**SUSQUEHANNA STEAM ELECTRIC STATION
SUBMITTAL OF REVISED UNIT 1 CYCLE 19
CORE OPERATING LIMITS REPORT (COLR)
PLA-7317**

Docket No. 50-387

Susquehanna SES Unit 1 Cycle 19

CORE OPERATING LIMITS REPORT

Figure 9.1
SSES Unit 1 Cycle 19 Power / Flow Map

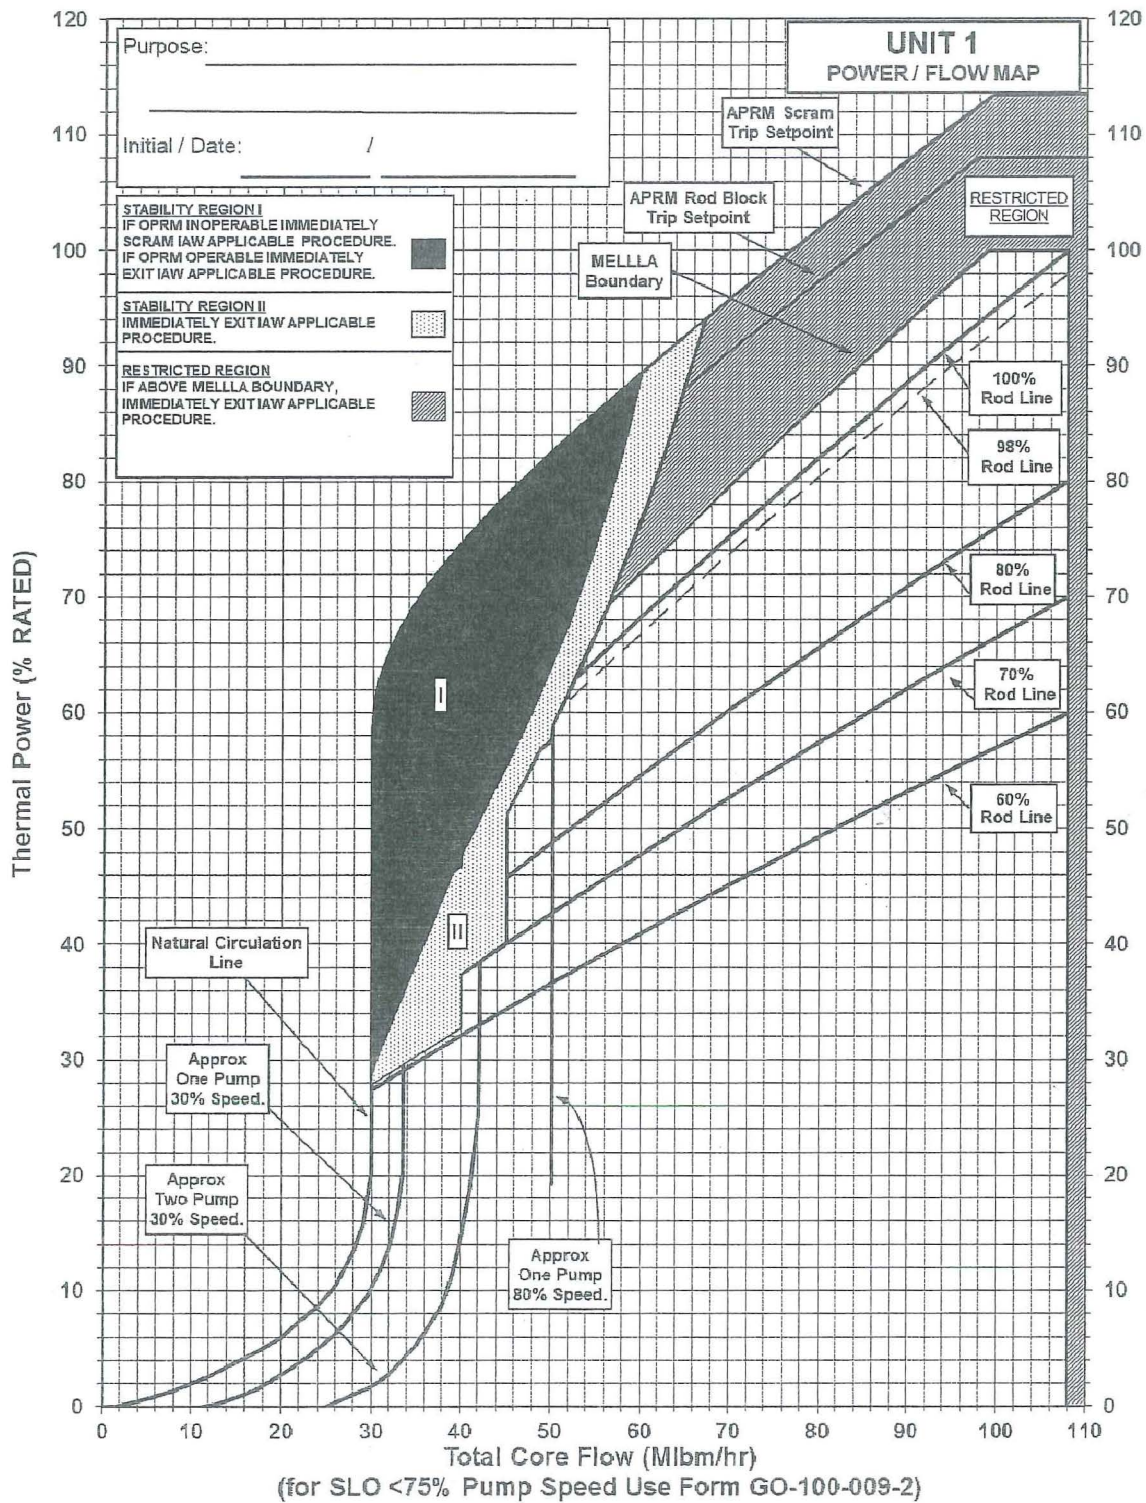
Technical Specification Section 5.6.5 requires that the Core Operating Limits Report (COLR), including any mid-cycle supplements or revisions, be provided upon issuance to the NRC in accordance with 10 CFR 50.4. In compliance with this requirement, a revision to the Unit 1 Cycle 19 COLR is provided in the attachment to this letter. The revision is an editorial change to the power/flow map

Rev. No.	Affected Sections	Description/Purpose of Revision
0	ALL	Issuance of this COLR is in support of Unit 1 Cycle 19 operation.
1	ALL	New COLR required due to Power/Flow Map revision.
